ADDENDUM 2

CSP 22-68

Memorial Middle School Heating & Air Condition (HVAC) Improvements Funded through the Elementary & Secondary Emergency Relief (ESSER) Funds

April 8, 2022

SHEET NUMBER:	M3.11			
DBR Project Number	218007.002			
HA	JA	JB	---	---

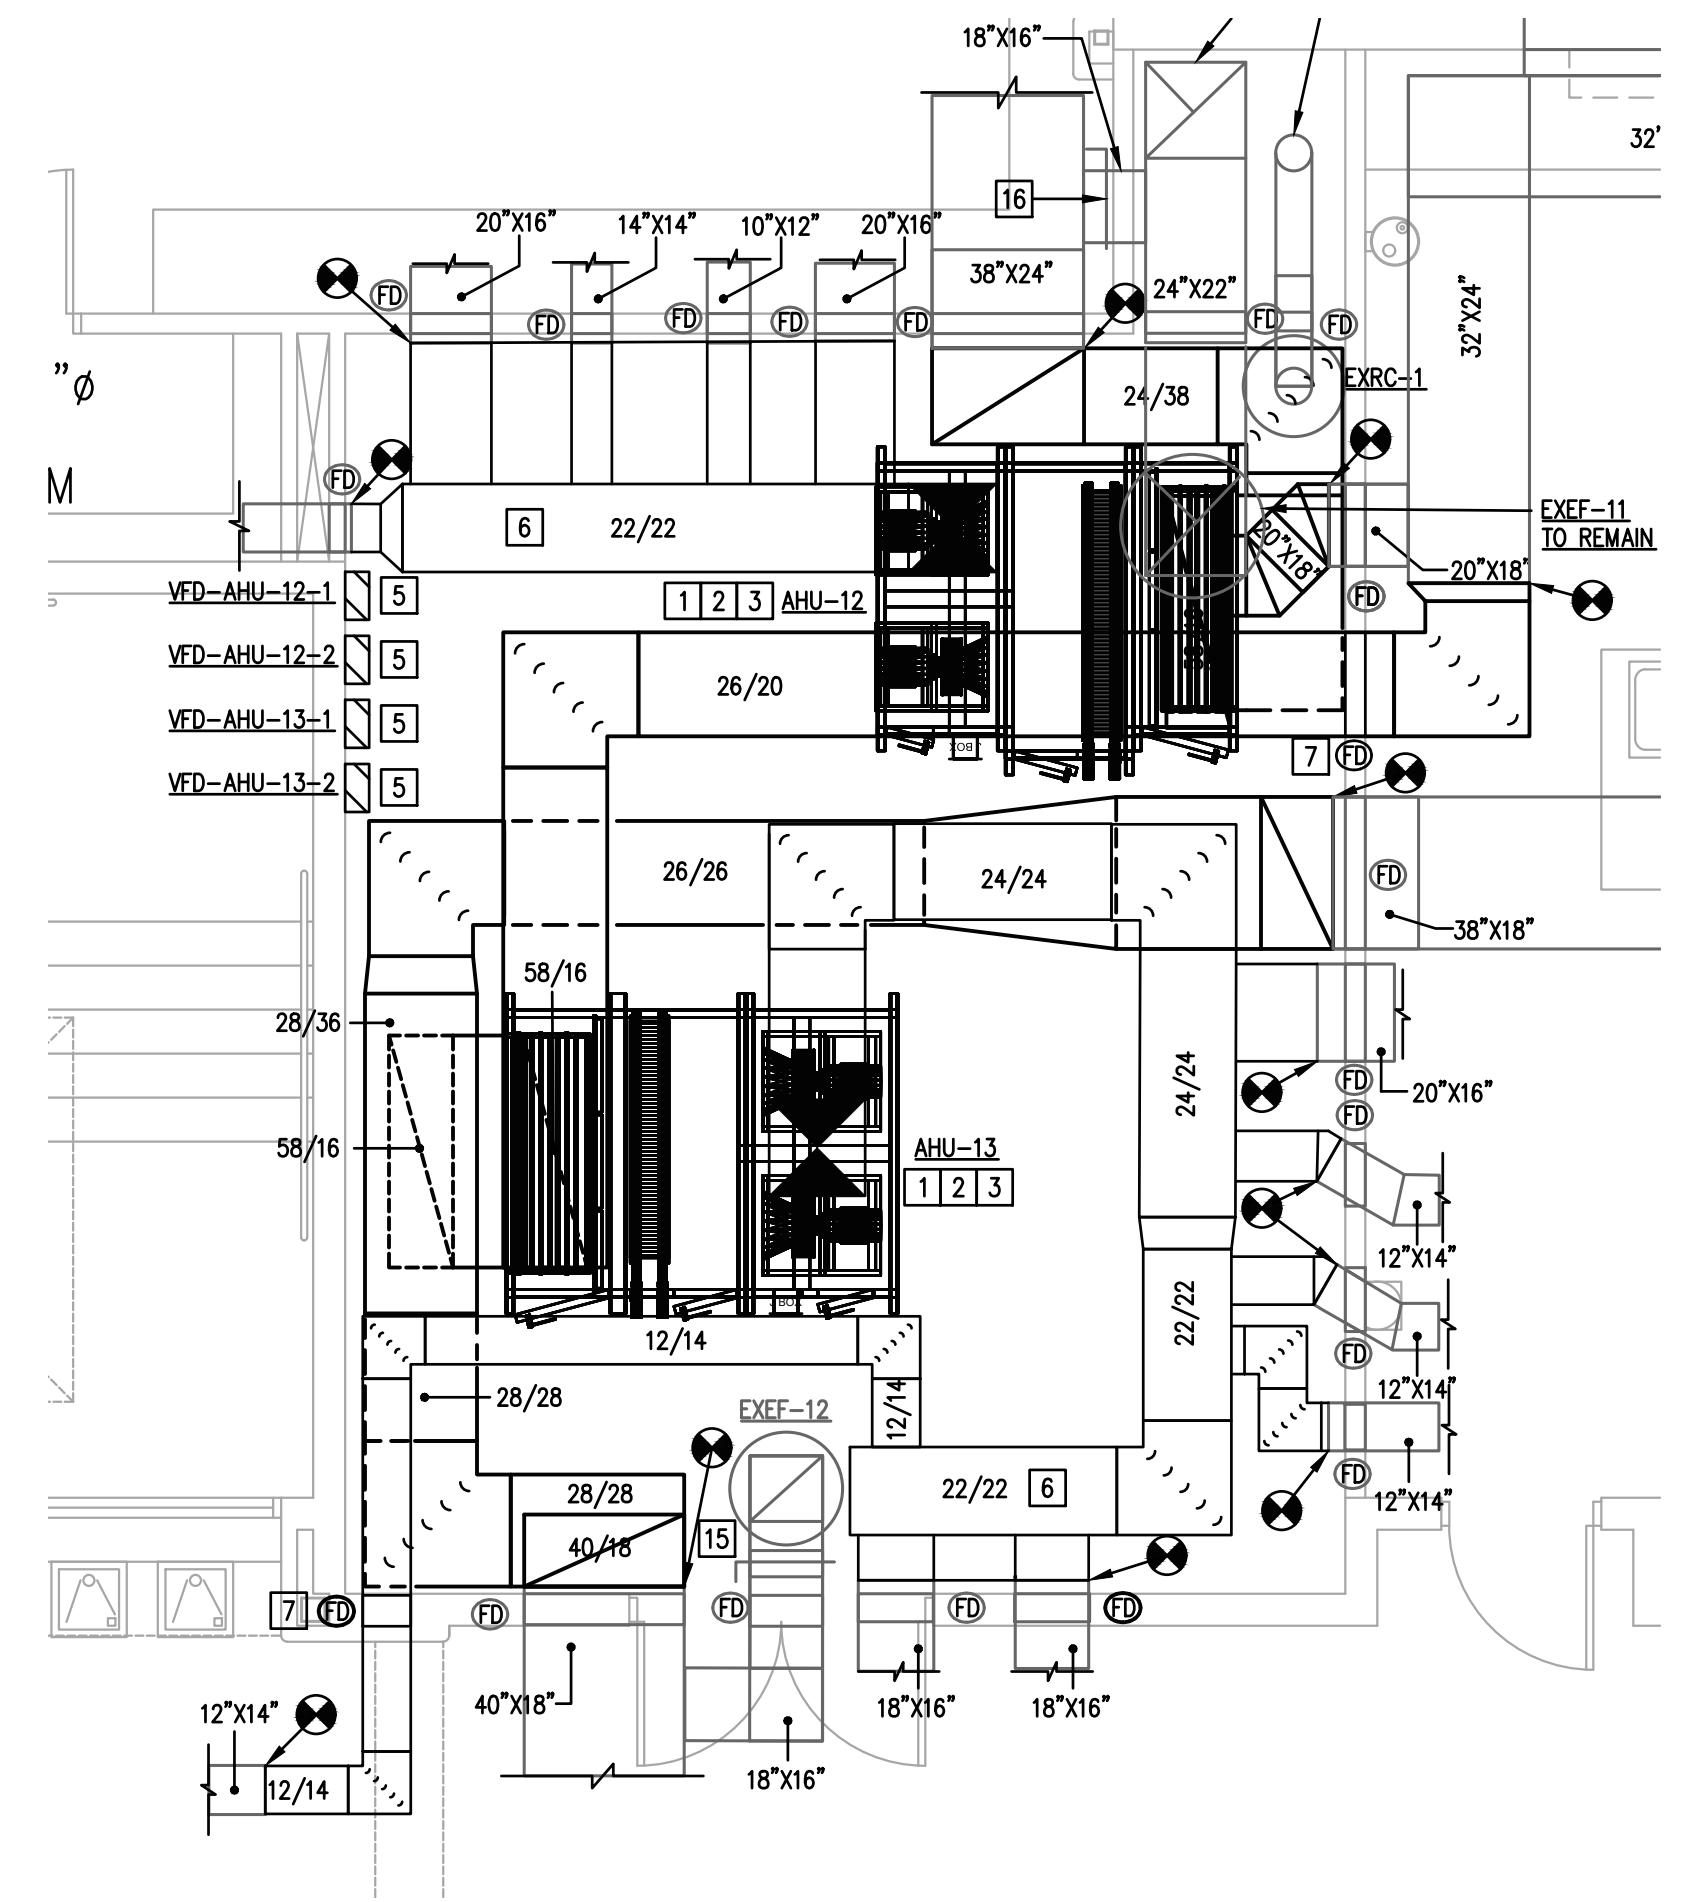
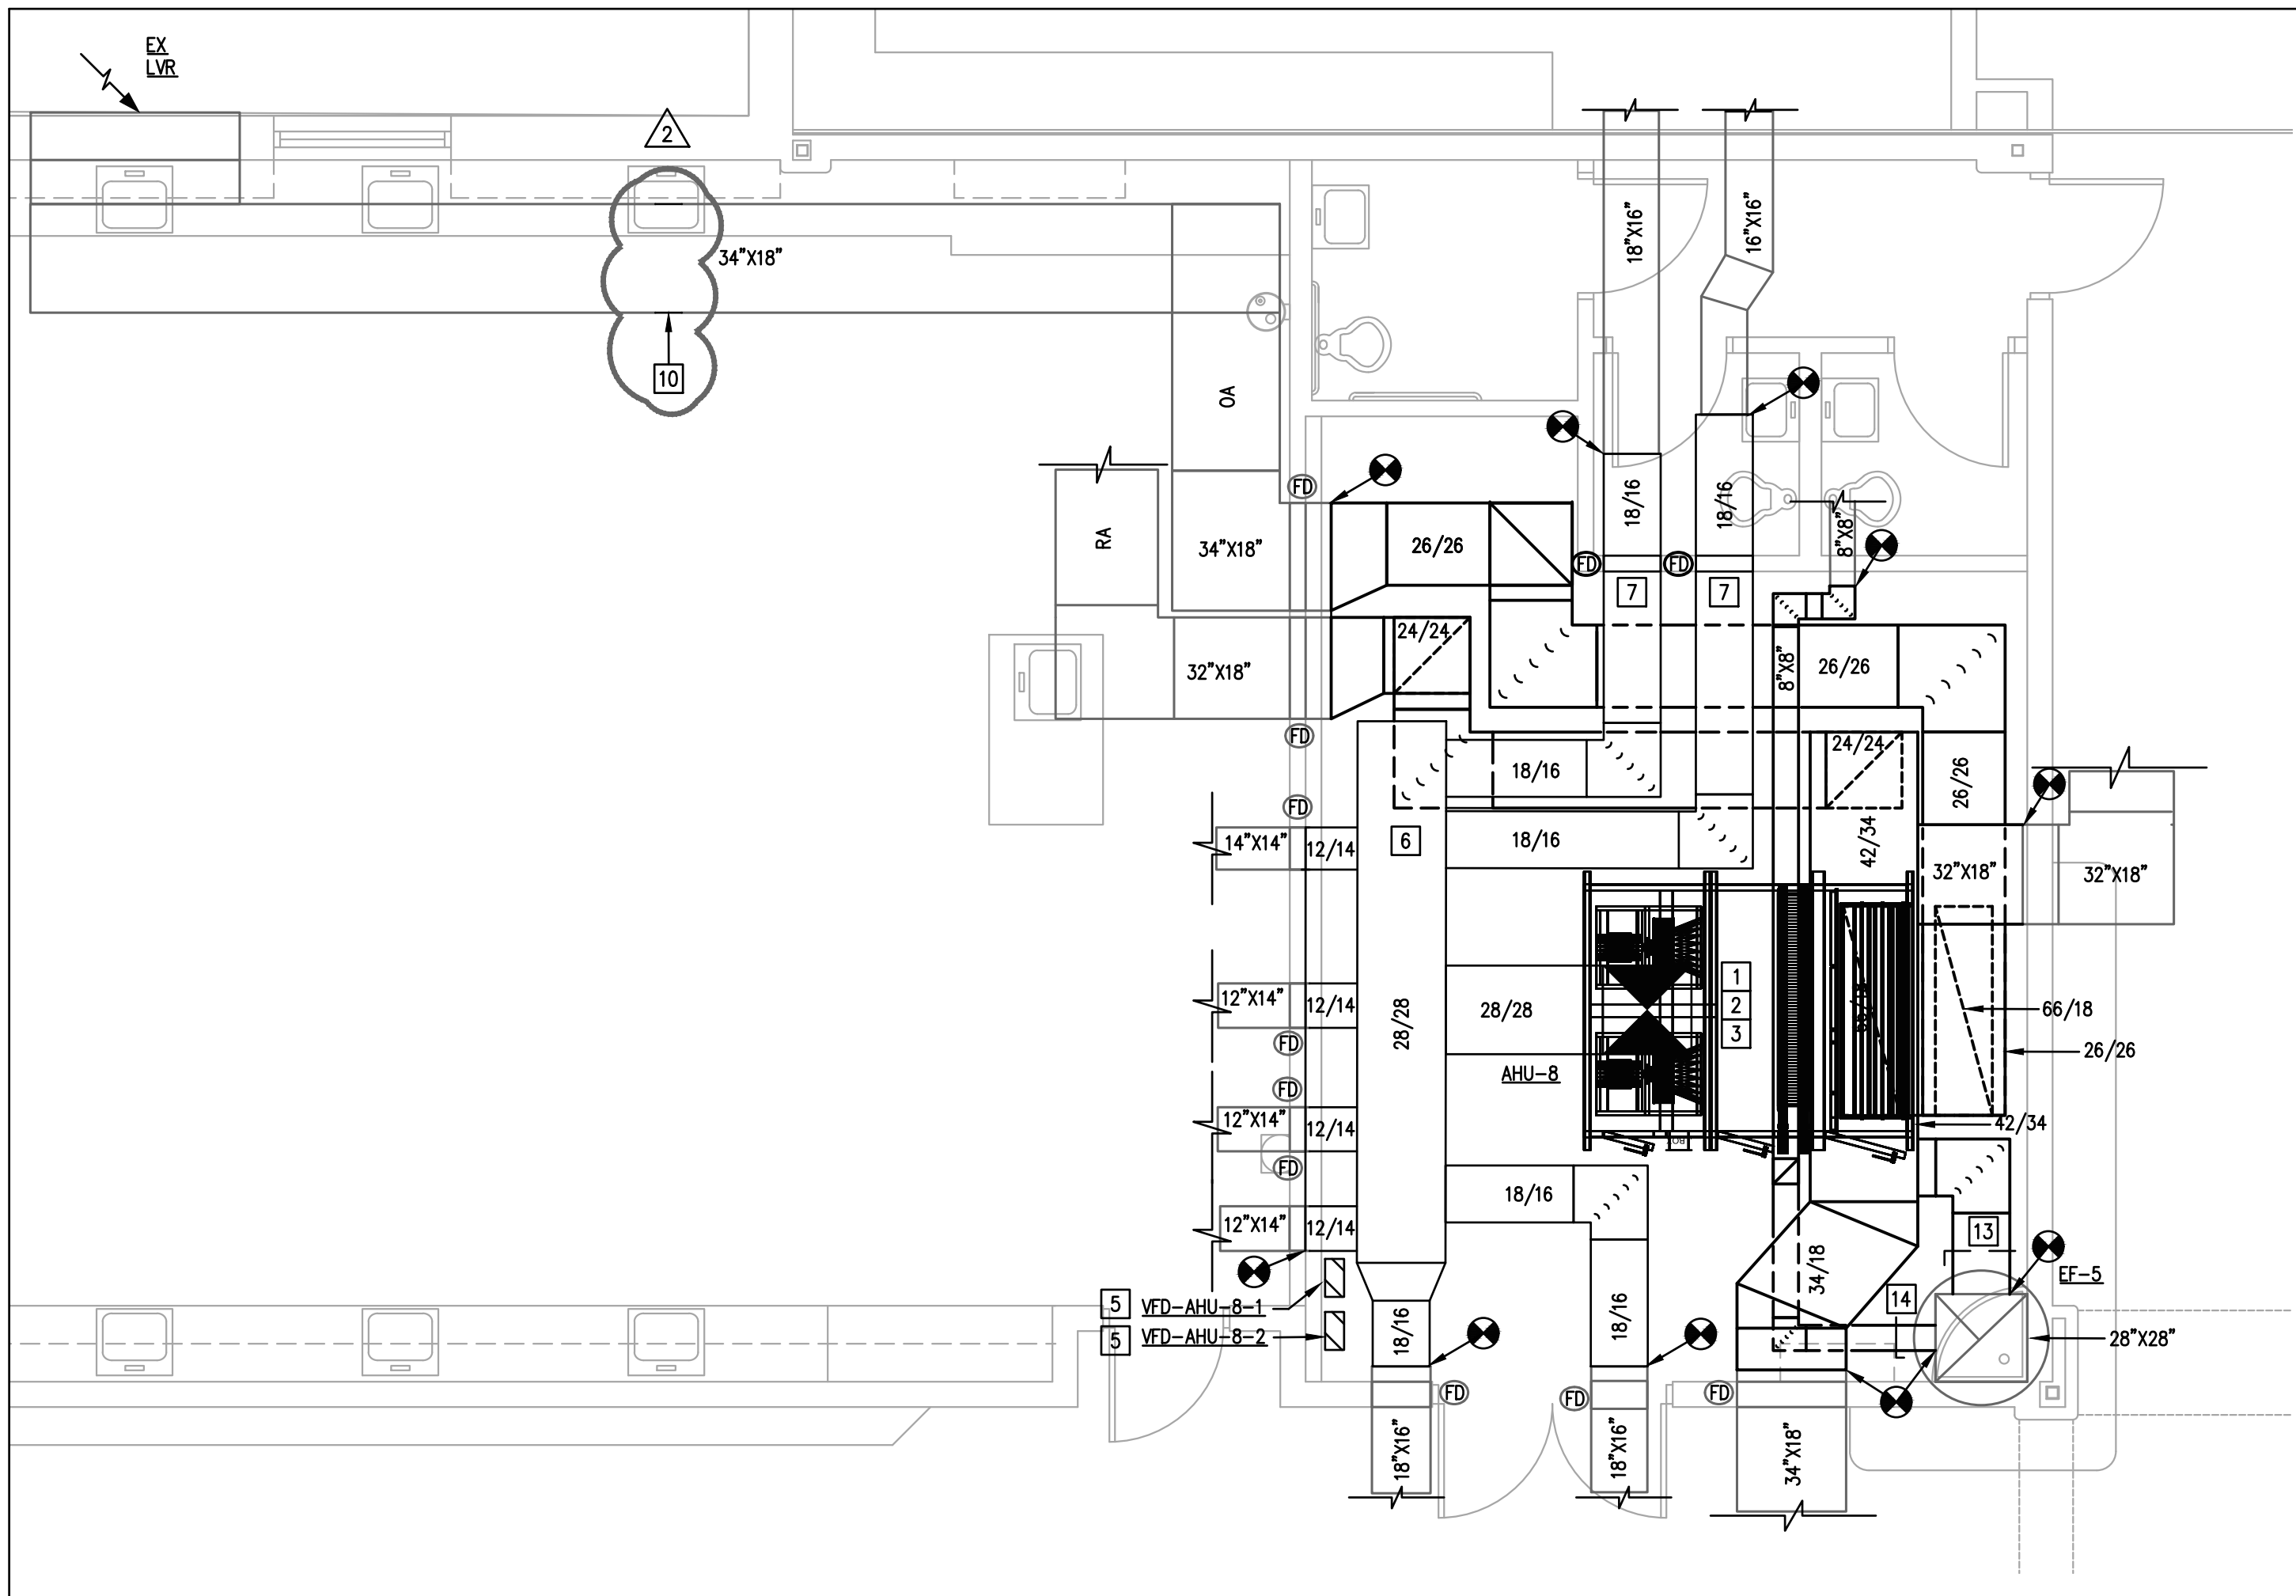
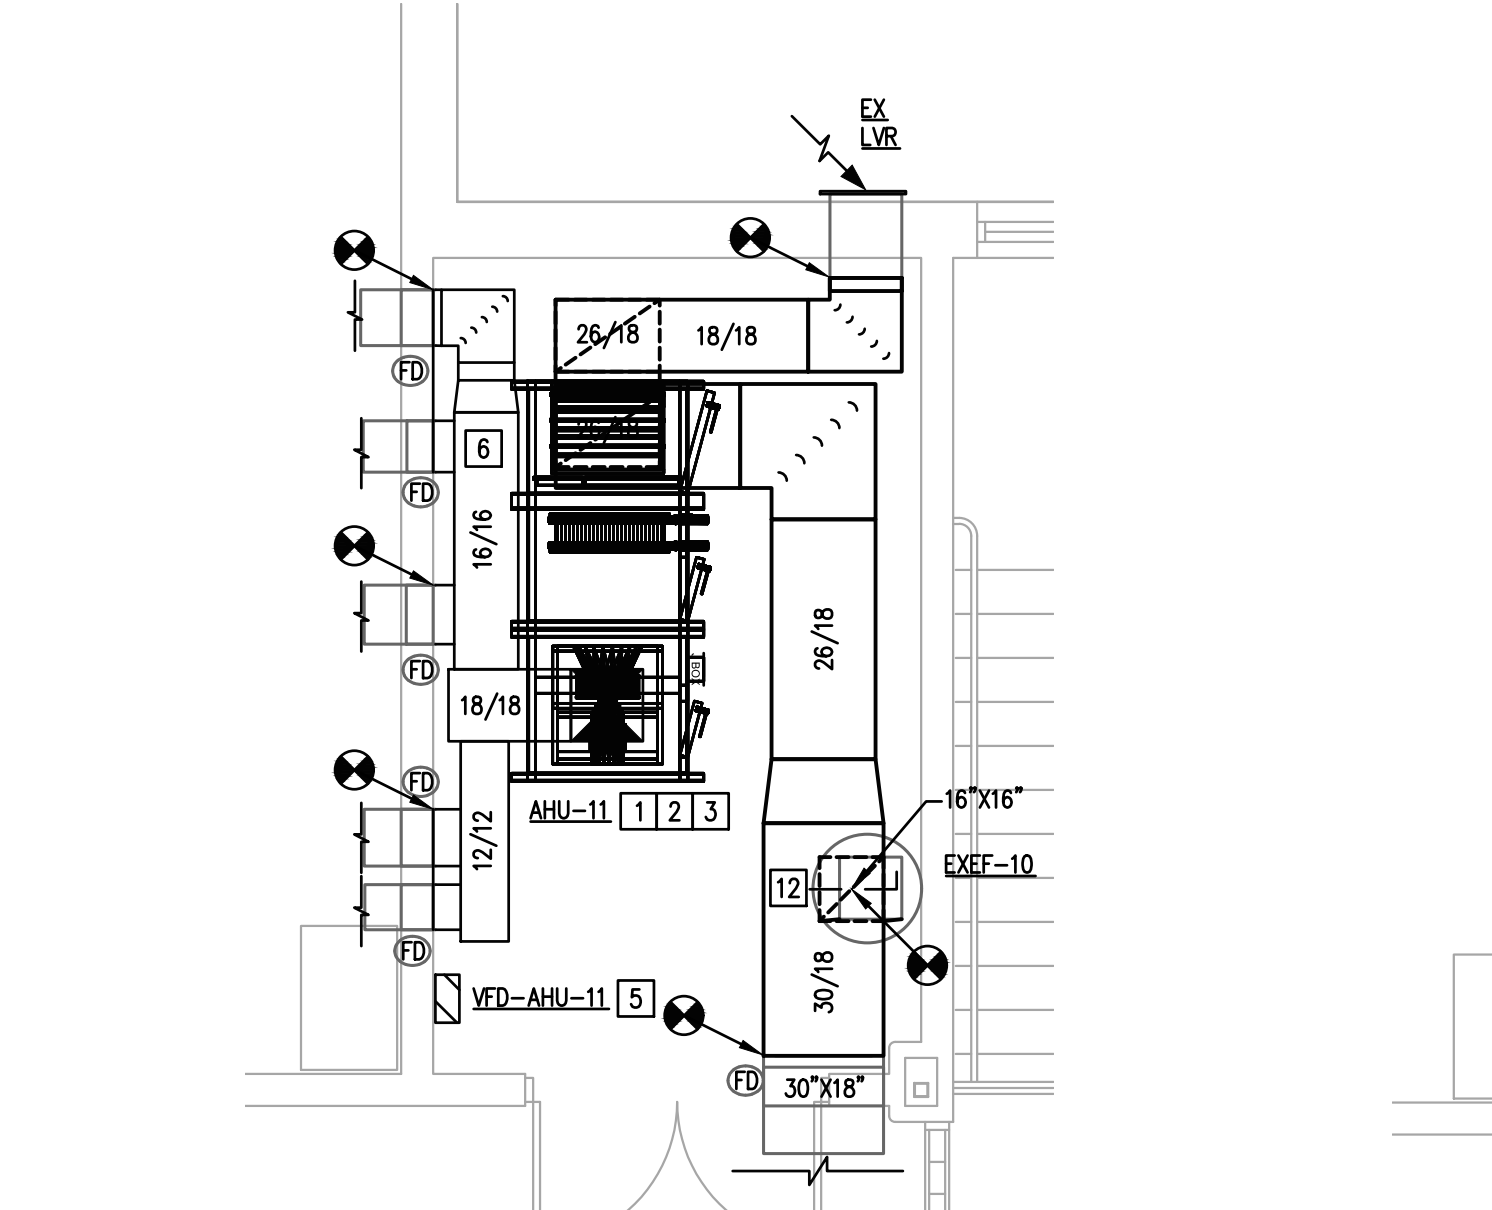
Item 13 SHEET M3.11 – ENLARGED MECHANICAL ROOM PLANS

A. Replaced keyed note 5 with keyed note 10 on LEVEL 2A MECHANICAL AHU-8.
B. Revised view of LEVEL 2B MECHANICAL AHU-9.
C. Revised view of LEVEL 2B MECHANICAL AHU-10.
